# Outcomes detailed commentary

PR24 Draft Determination Representations – August 2024

## Outcomes Detailed Commentary

Figure 1 Industry CRI performance

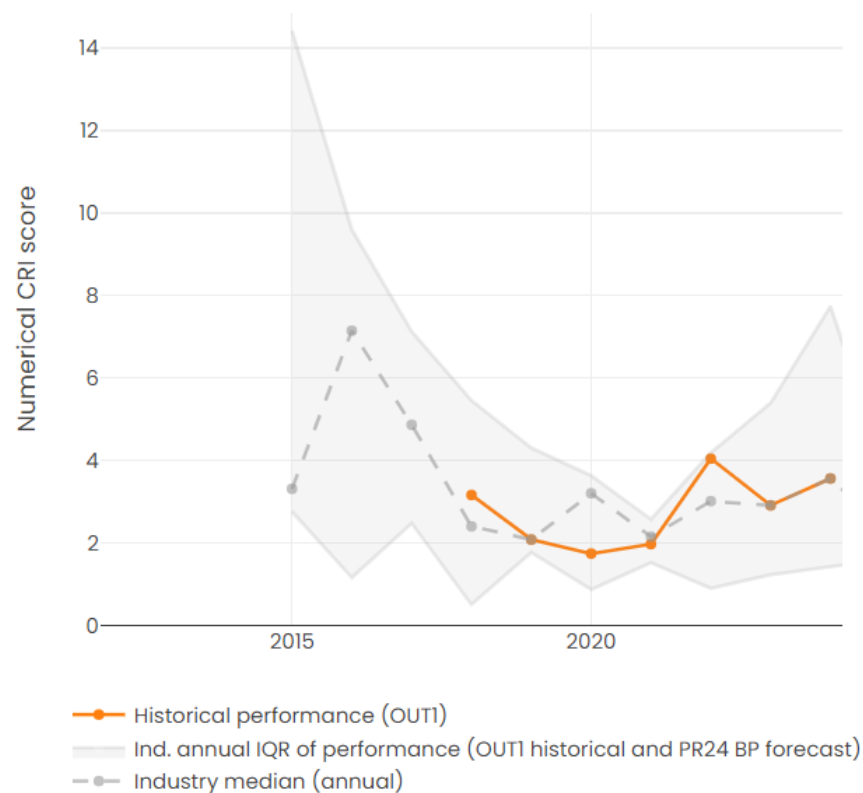
The CRI score of two, proposed as the alternative deadband, is in line with the baseline performance expected by the DWI in the annual Chief Inspector’s report. The Chief Inspector of the DWI discussed CRI at the Chief Inspector’s Report launch on 11 July 2023. He recognised there is a residual risk associated with drinking water quality even when companies are providing excellent quality drinking water. Therefore, they stated it is unrealistic not to accept this residual risk at company assets and customer properties exists and a deadband remains appropriate for this measure. At the time of writing, we are not aware of any public statement from the DWI on an updated expectation of baseline performance, therefore we maintain that the current deadband score of 2 remains appropriate. We observe that this remains lower than the industry median in the last three years.

We are also concerned about the phased reduction in the deadband over AMP8. The challenges in meeting the full compliance that Ofwat set out in the Final Methodology (Appendix 8, page 68) related to customer internal pipes or fittings apply for the entirety of AMP8. These factors remain outside the statutory functions of water companies and this risk will not diminish during the AMP as the deadband implies. The factors that drive the requirement for the deadband will remain unchanged throughout the price review period, making it appropriate to maintain the deadband at the same level throughout AMP8.

We propose the deadband be set at a CRI score of 2 for each year of the AMP, consistent with the deadband for most companies in AMP7, given the information outlined above.

**Figure 2 Discharge Permit Compliance: Ofwat Draft Determination implied RORE impact compared to the ratio of permits to regulated equity**

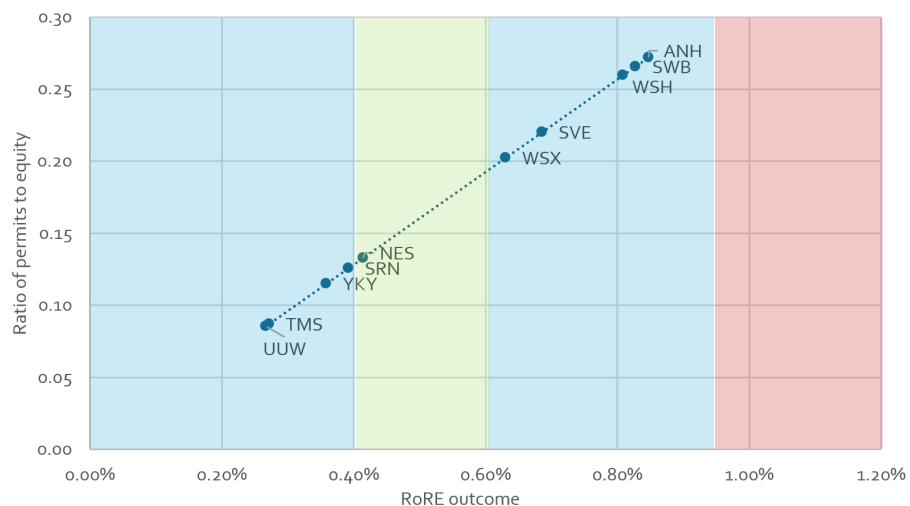
The figures below demonstrate these points. They show the implied RoRE impact from the rates on the x axis compared to the ratio of permits to regulated equity on the y axis. The first graph presents the results from the Draft Determination for all of the companies in the 'Large RCV' group and therefore includes AFF and SEW due to the grouping set out by Ofwat.

The first point on the structural difference between WaSCs and WoCs is illustrated by how the points for SEW and AFW sit below the WaSCs in the first graph. By removing the WoCs in the second graph the WaSCs move to sit on the trend line.

This also has the effect of narrowing the range of implied RoRE impacts. This is illustrated by the three companies in the red section in the first graph (WSH, SWB and ANH) moving into the blue section in the second graph.

We therefore believe that in addition to excluding WoCs from the calculation of the incentive rate, Ofwat should either apply a scaling factor to reflect the ratio of permit to regulated equity (the higher the permits the lower the rate) or apply individual companies implied rates without taking the median to avoid the relationship between permits and equity biasing the calculation.

**Figure 4 Regulated Equity compared to number of permits**

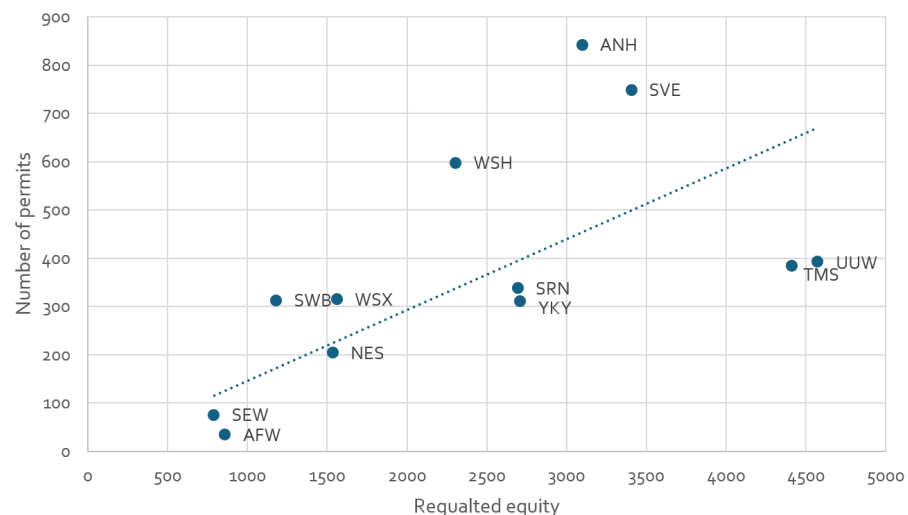
We also note that both Thames Water and United Utilities have a low number of permits compared to their regulated equity and this is driving a low level of RoRE risk.

**Figure 5 Serious Pollution Incidents, initial ODI rate, £m**

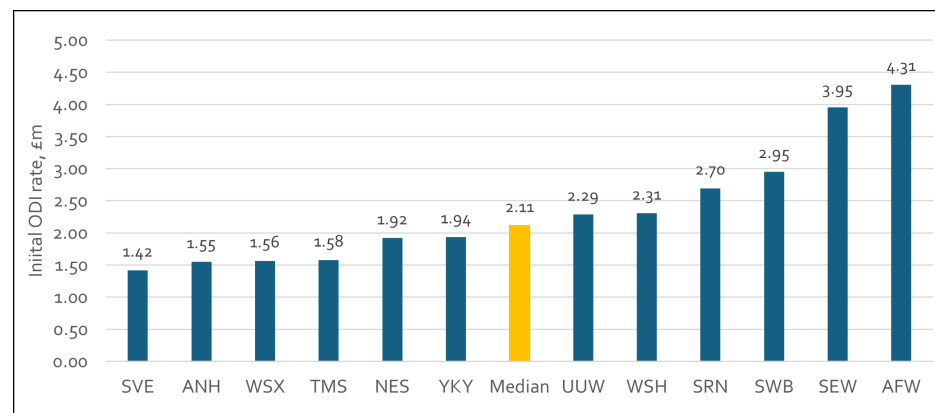
The graph below showing the initial ODI rates per incident illustrates the first point, clearly showing that the two WOCs are outliers. These are the initial ODI rates estimated prior to the median being calculated<sup>7</sup>

We propose that Ofwat should remove WoCs from the incentive rate calculation, adjust the proxy PCL to 0 and remove double count from calculations to reduce unit rates.

Figure 6 Number of incidents per 10,000 km of water and sewerage network

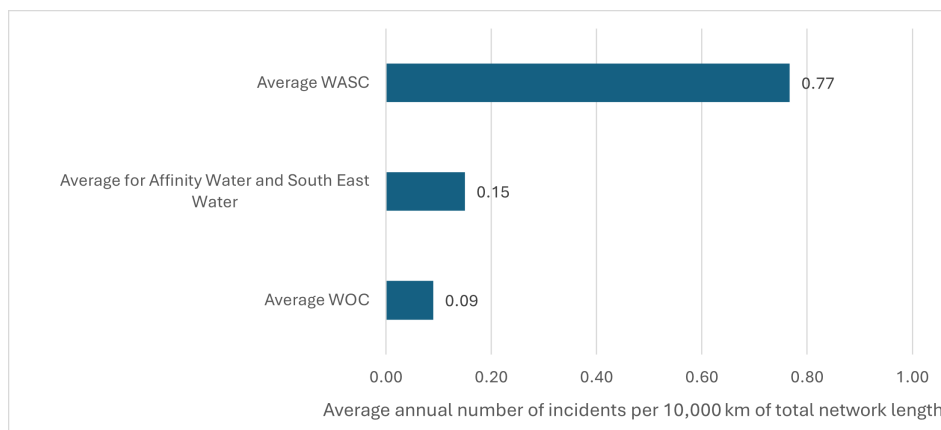
To illustrate the second point, that WoCs are structurally different to the WaSCs we present the normalised number of pollution incidents per total network length. The data is based on 12 years of data that Ofwat use in the performance model for serious pollution incidents. We also note that in Ofwat's modelling of ODI risk in the DD, Ofwat's risk models exclude the WaSCs as part of the top-down cross check.

This shows that the rate for WaSCs is significantly higher than for WoCs:

Figure 7 Serious Pollution Incidents P10 in each year over time

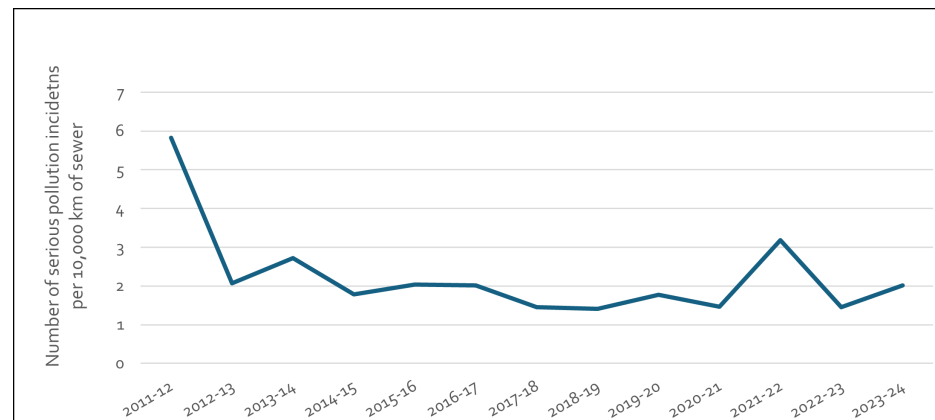
With the exception of 2011-12 the P10 for each year has remained consistent over time.
